UNITED STATES PATENT AND TRADEMARK OFFICE

APPLICATION NO.	FILING DATE	FIRST NAMED INVENTOR	ATTORNEY DOCKET NO.	CONFIRMATION NO.
09/854,190	05/11/2001	Tomoo Fujioka	Y-183	7211

Office Action Summary

DETAILED ACTION

FIG 1

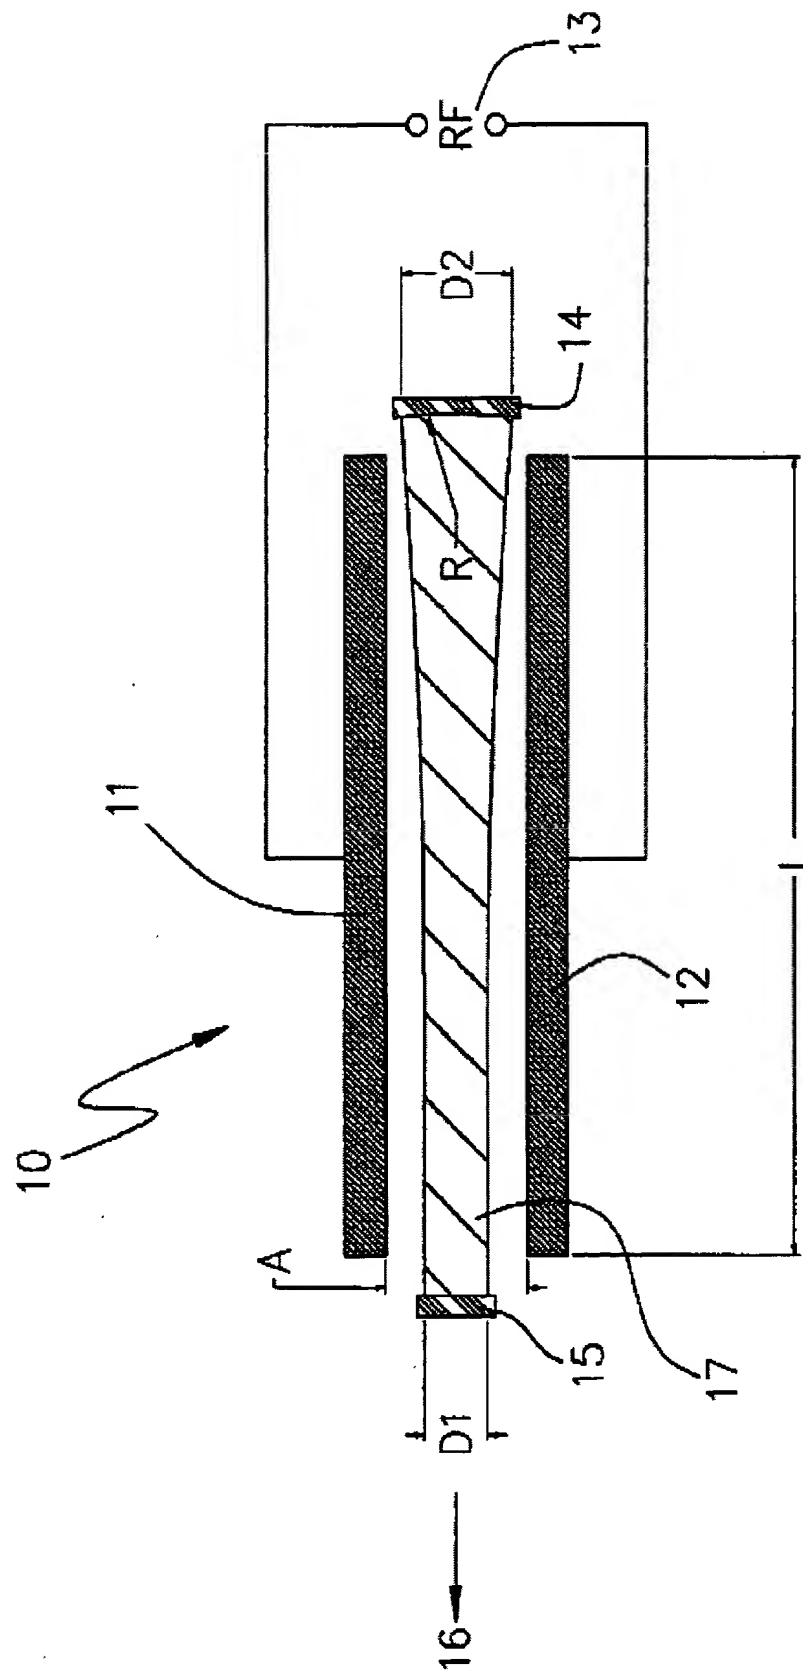
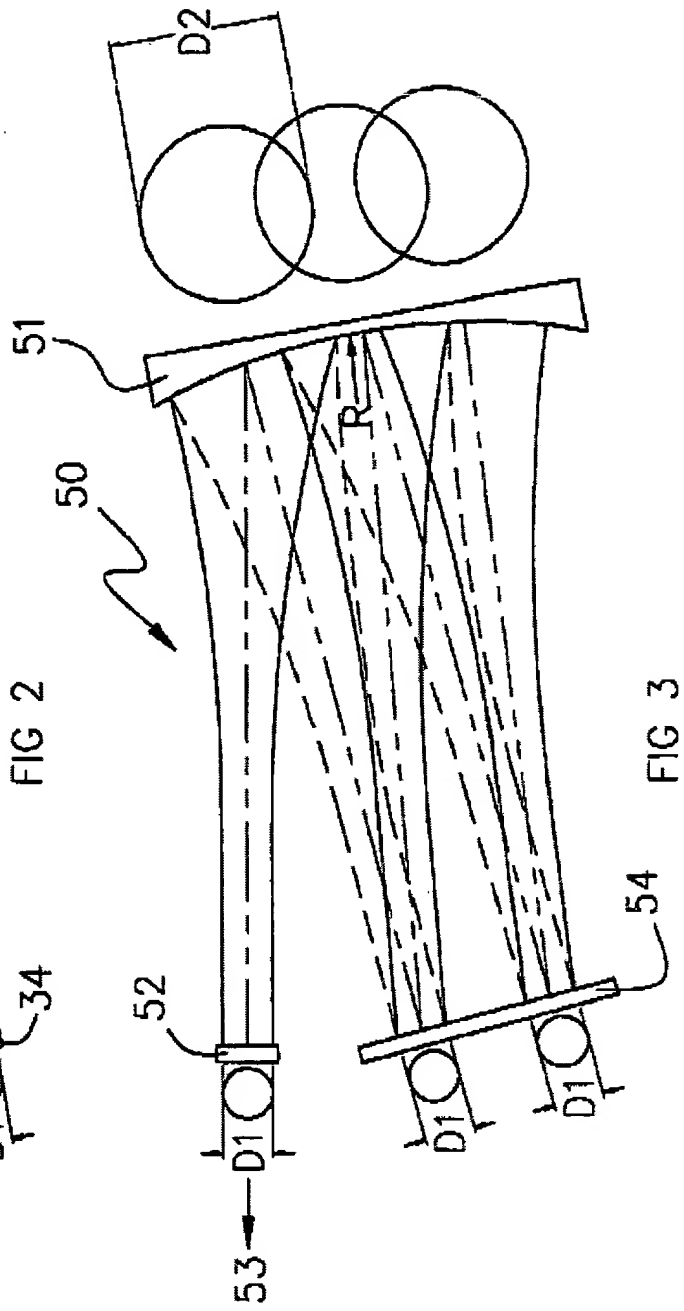
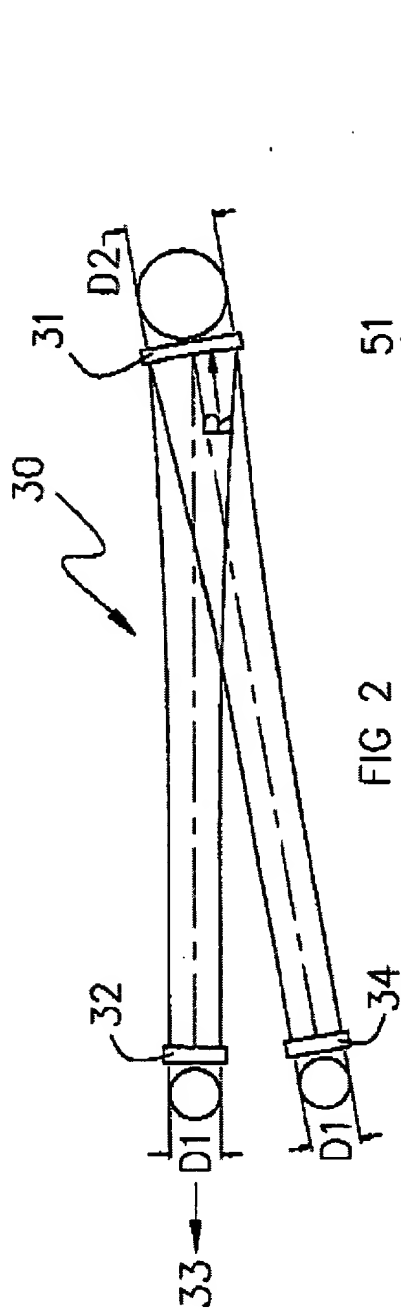
With respect to claim 1, Sukhman et al disclose free-space gas slab laser comprising a gas slab laser (10), a pair of cylindrical electrodes (11, 12), the spacer (99), the gap (40), an output mirror (15) is output coupler only partially reflective emitting laser light beam (16), the Gaussian beam (17), the reflective mirror (14), the diameters (D1 and D2), note cols. 6-13, see figs 1-12. However, Sukhman fails to discuss about w-axicon mirror disposed at the other end of the straight slab and the center position. Whereas Holmes et al disclose the w-axicon mirror disposed at the other end of the straight slab and the center position, note cols. 1-5, see figs. 1-6. For the benefit of the w-axicon mirror disposed at the other end of the straight slab and center position, it would have been obvious to one having ordinary skill in the art at the time the invention was made to provide Sukhman with the w-axicon mirror disposed at the other end of the straight slab and the center position as taught or suggested by Holmes.

With respect to claim 2, Sukhman et al discussed about the partial relationship between the diameter of the Gaussian beam of the fundamental mode and the electrodes inside of the free space slab laser, note cols. 5-6, see fig 1.
